Title				
SCHEMATIC FOR MAIN PCB				
Model	Size	Number	PCBUW222	Rev
PCBNO	A2			5
DES' BY	Surajit	Date	11.9.01	Drawn by
CHK' BY		Filename	MAIN.S01	Sheet
APP'D BY				1 of 5

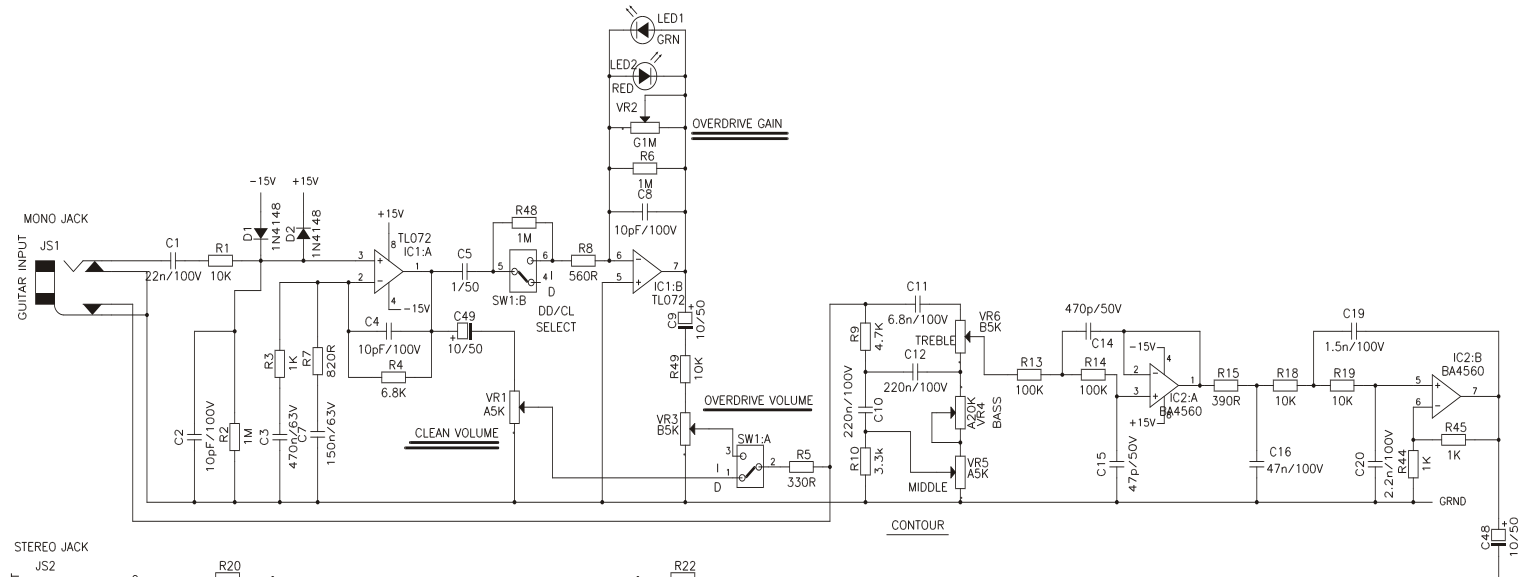
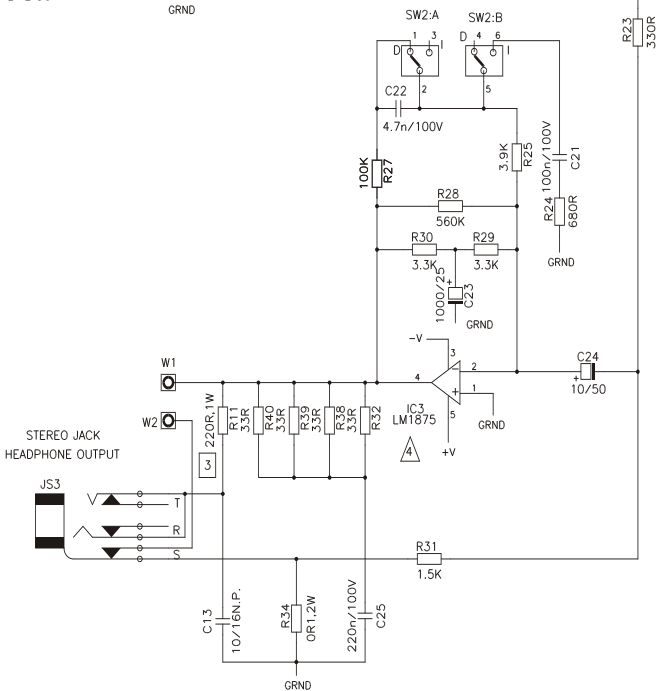
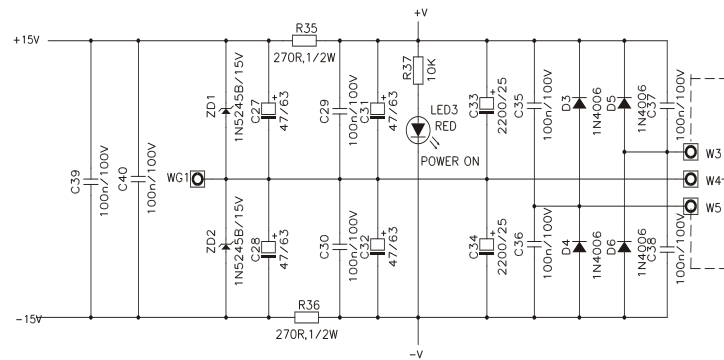
5	8.2.03	IN LINE FUSE ADDED		
4	5.8.02	IC3 WAS TDA2050	Surajit	
3	24.5.02	R11 WAS 680R CHANGED TO 220R,1W AS PER E-MAIL DT. 14.5.02 C5 IS N.P. CAP.	Surajit	
2	8.12.01	R11 WAS 1.5K,1/4W & C33,C34 WAS 1000/25 (changes as per E- mail dt.7.12.01)	Surajit	
REV	DATE	DESCRIPTION	SIGN	APP'D
